TITLE:-4LEAF BOTH SIDE SLIDING
CRM DOOR-10/Gate 24

CLIENT - LESTECH
LOCATION - POSCO MANGAON
PRODUCT - SLIDING DOOR
If any queries contact : design@nihva.com
DWG NO:-NIHVA/22-23/CLT/0017 REV- 1
ALL DIMENSION ARE IN mm
SCALE: NTS SCALE:-- 1:1 SHEET: 01 OF 01

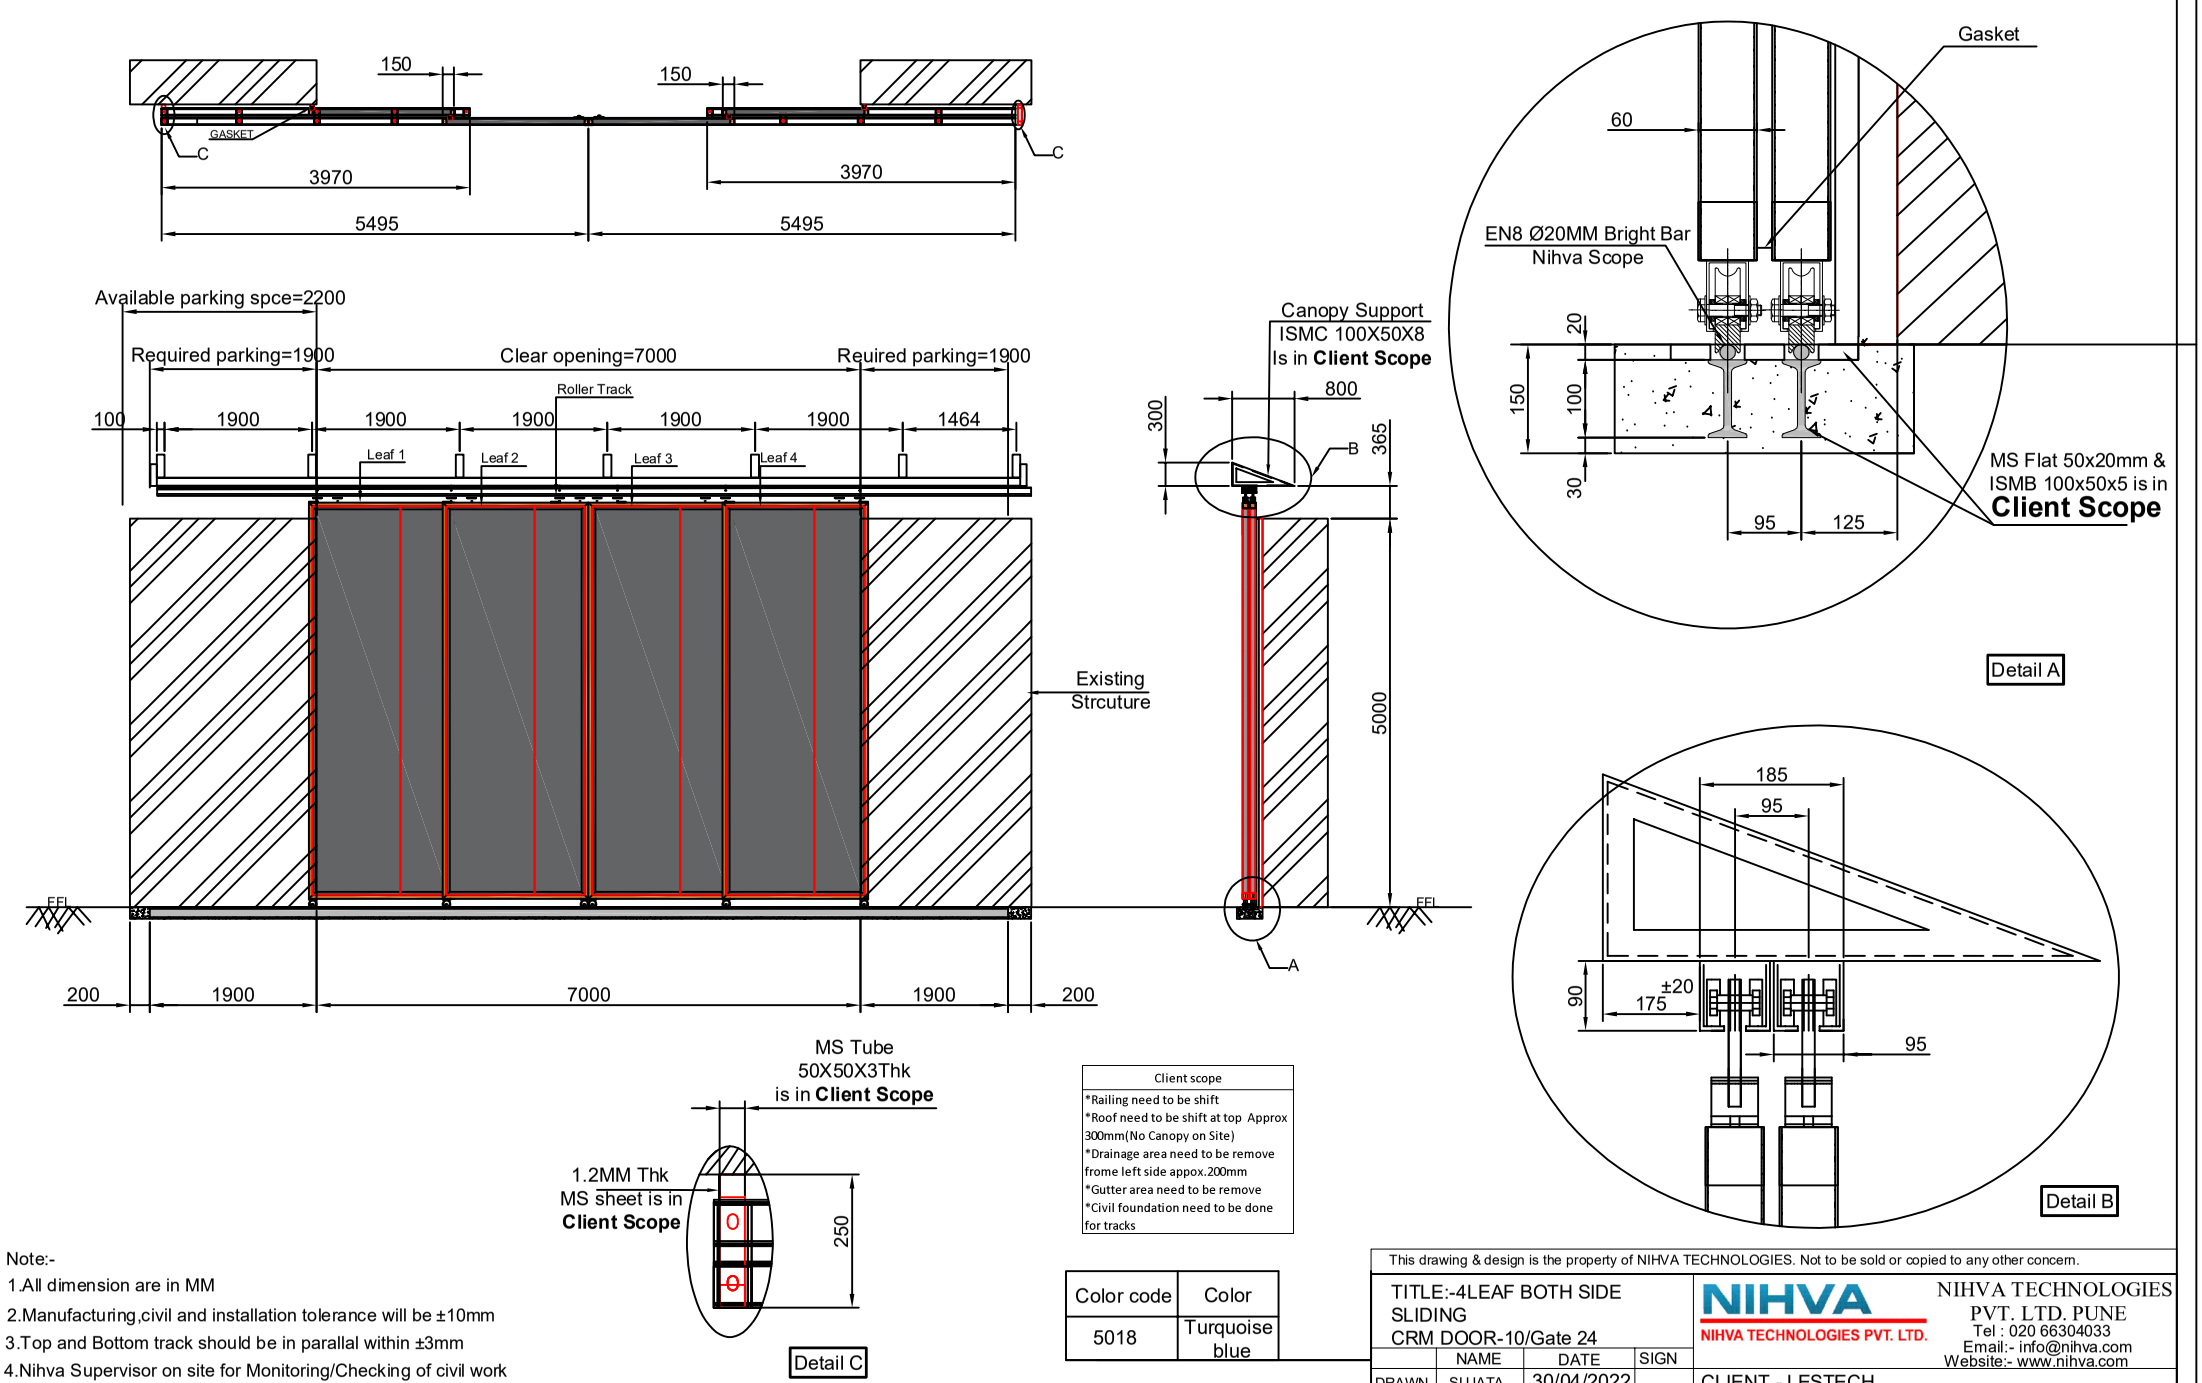
| Client scope |
|---|
| *Railing need to be shift |
| *Roof need to be shift at top Approx 300mm(No Canopy on Site) |
| *Drainage area need to be remove frome left side appox.200mm |
| *Gutter area need to be remove |
| *Civil foundation need to be done for tracks |
